KIAORA LANDS REDEVELOPMENT  
ASSESSMENT REPORT

DEVELOPMENT APPLICATION 531/2011/1

SYDNEY EAST JOINT REGIONAL PLANNING PANEL  
MEETING 14 JUNE 2012

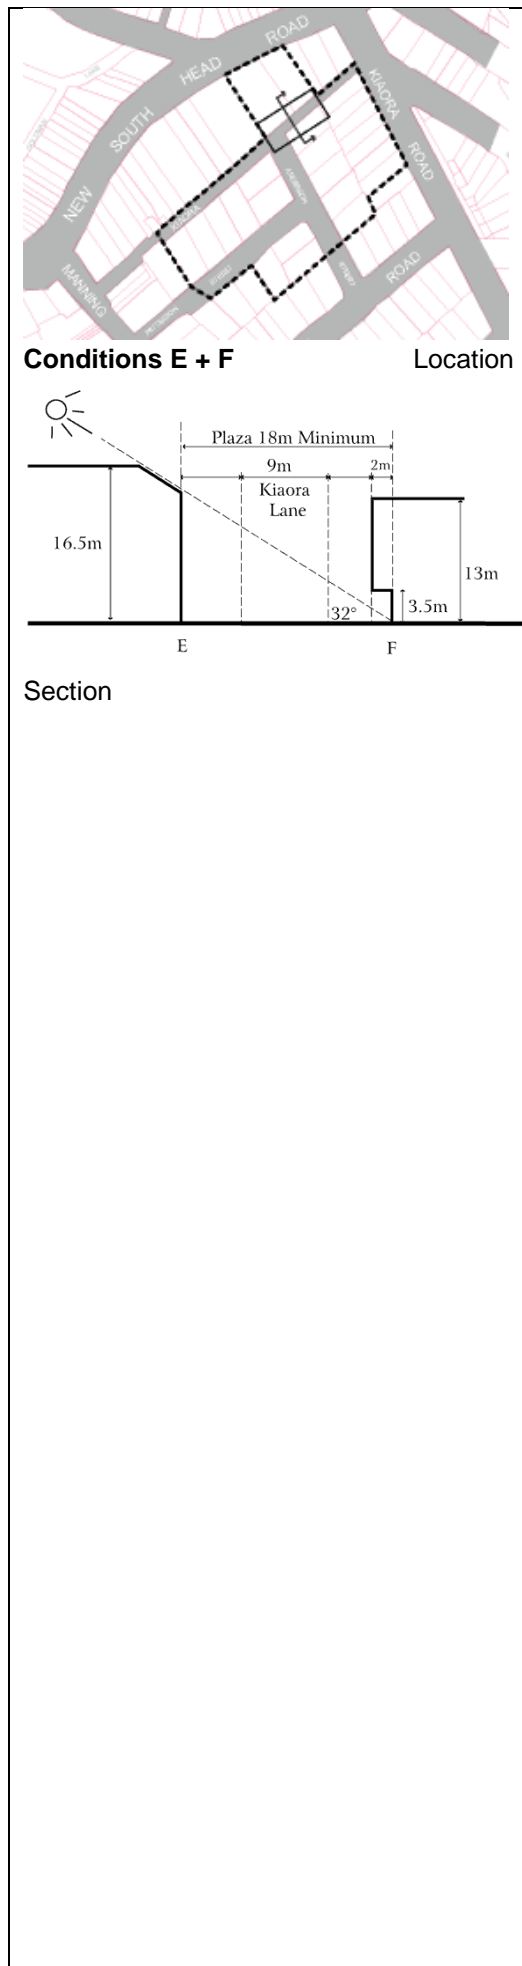
<p><b>Applicant's comment</b> <i>The proposed development is considered to be consistent with Condition E+F, refer to the Architectural Drawings included at Appendix B and the SEPP 1 objection at Appendix AA.</i></p> <p>The same assessment applies to the 16.5m height limit for edge condition E+F as for edge condition D although the proposed height of the parapet is 17.8m which exceeds the control by 1.3m.</p>

Regarding the 32 degree inclined plane, the central atrium style area above the arcade of the New South Head Road building complies. The main envelope of the building exceeds the height plane by a maximum of 6m for an overall length of 38m. This is a substantial departure from edge condition E as per the diagram. In relation to the 32 degree inclined plane, edge condition E allows consideration to be given to a variation in the following terms:

*Variation to the inclined plane may be considered if the principal dining/public area on the south side of the plaza has sunlight access at 12 noon in mid winter.*

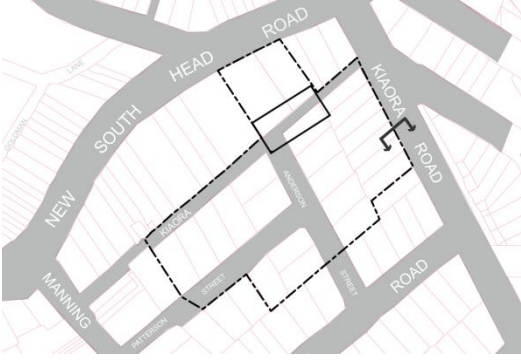
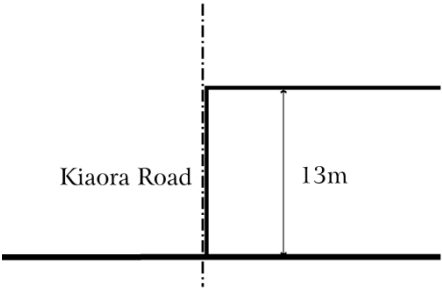
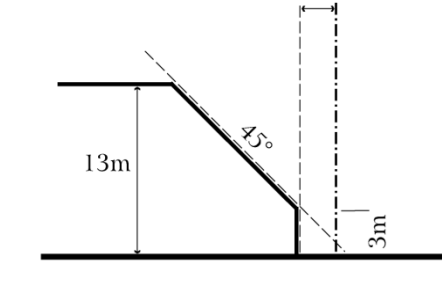
*Drawing No. 3109\_SK581 demonstrates the existing proposal with a 32 degree incline plane aligned to true north. The top floor of the Library Building is impacted by some 4.86 metres as shown in Drawing No. 3109\_SK 580. If strict compliance was required this would result in some 74.9 square metres of library floor space of the Library Building being diminished at level 4.*

*It is evident that a 32 incline aligned with true north and not 90 degrees to the building as shown in the control,*

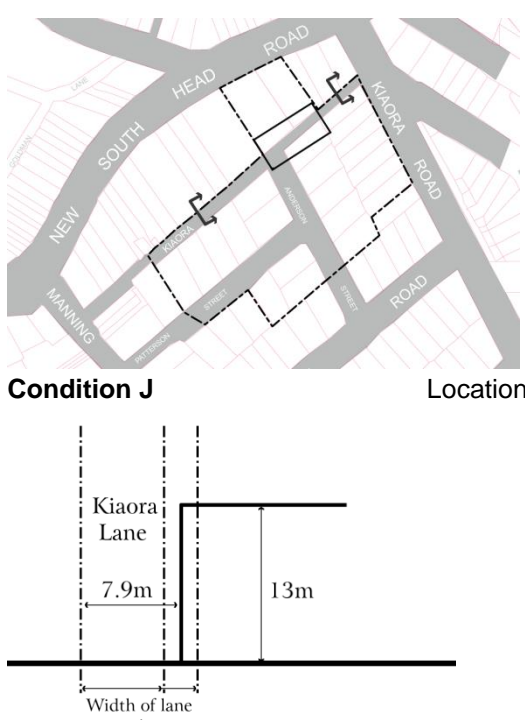
<p><b>Condition J</b> Location</p> <p><b>Section</b></p>	<p><b>Applicant's comment</b> <i>The proposed development complies with Condition J, refer to the Architectural Drawings included at Appendix B.</i></p> <p>The proposal complies with the 7.9m setback from the northern boundary of Kiaora Lane. It also complies with the 13m height at the Kiaora Lane frontage, apart from lift/stair enclosure. The lift/stair enclosure attains a height of approximately 14.25m. The enclosure has a length of 11.4m to Kiaora Lane compared to the overall length of the building of 172m which represents about 6%.</p> <p>The 13m edge condition height is the same as the statutory height under the WLEP. This non-compliance with the height standard was drawn to the applicant's attention by email dated 21/2/12. The applicant subsequently revised the SEPP 1 objection for the Kiaora Lane building to also include this lift/stair enclosure. The SEPP 1 objection has been discussed earlier in this report and the height of the lift/stair enclosure, despite its breach of edge condition J, is considered to be acceptable for the reasons referred to in the SEPP 1 objection.</p>
